# STONE WAY APARTMENTS

*DESIGN RECOMMENDATION MEETING*

DPD #3011897

JANUARY 23, 2012

LANDSCAPING TO ENHANCE  
THE BUILDING AND/OR SITE

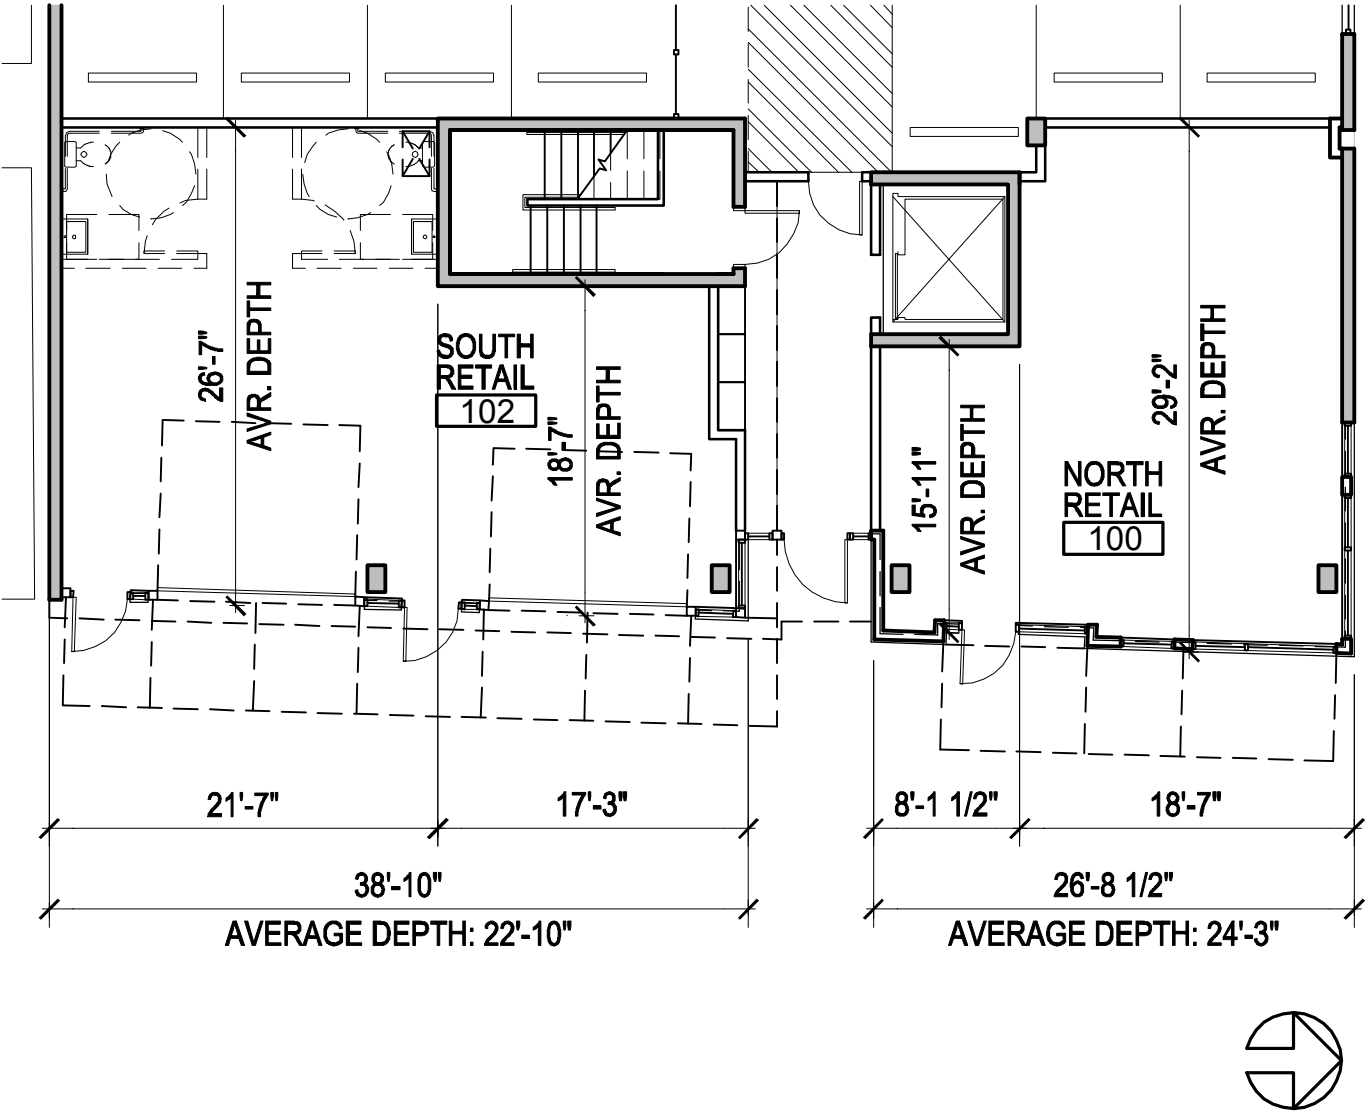
*Early Design Guidance: Employ landscaping techniques, such as those stated in this guideline, to provide privacy and a buffer between the single family houses to the west and south and the upper level residential units.*

Appropriate groundcover and street trees will be used along the Stone Way ROW. Landscaping along the edge of the roof terrace will be visible from grade and enhance the building’s massing. The paving at the residential entry has a different scoring pattern to help differentiate it from adjacent retail uses. Since the EDG, SDOT has required removal and replacement of the existing Norway Maple tree in order for the alley entrance to be widened to SDOT standards. The Ciry Arborist has been consulted and agrees with the tree removal. The owner will install mature “stock” trees in the ROW that are approximately 15-18 years old.

The project owner has contacted the adjacent single family homeowner and has agreed to plant three trees on the homeowner’s property. The landscape architect provided a list of trees, and the homeowner has selected three different species. The homeowner will determine the specific location for these trees prior to installation.

DEPARTURE REQUEST

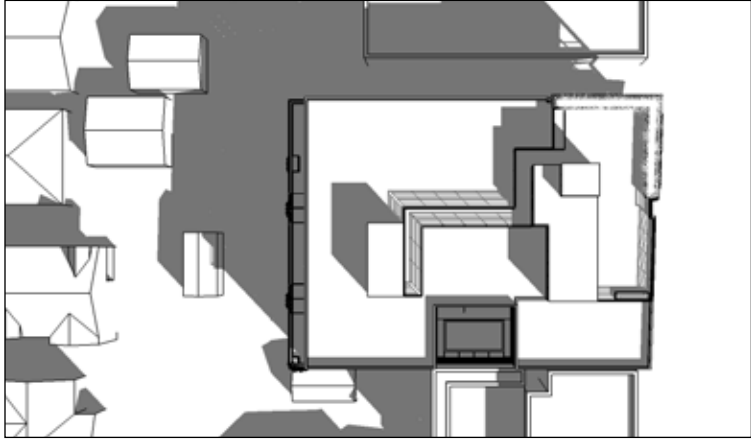
The project proposes a reduction for minimum retail depth (SMC 23.47A.008.B.3.a). The unusual site constraints for on-site parking make a 30’ average depth for retail space along Stone Way impractical. While it is possible to provide a 30’ depth, it would severely limit the number of on-site parking stalls and negatively impact existing neighborhood parking. In addition, the Owner has secured a tenant who is interested in opening a café and has signed a letter of intent to rent the space for 10 years. The tenant has already indicated that the proposed depth will work for their use. There is a benefit to having this retail space filled with a service that many in the community will use over adding additional off-site parking.
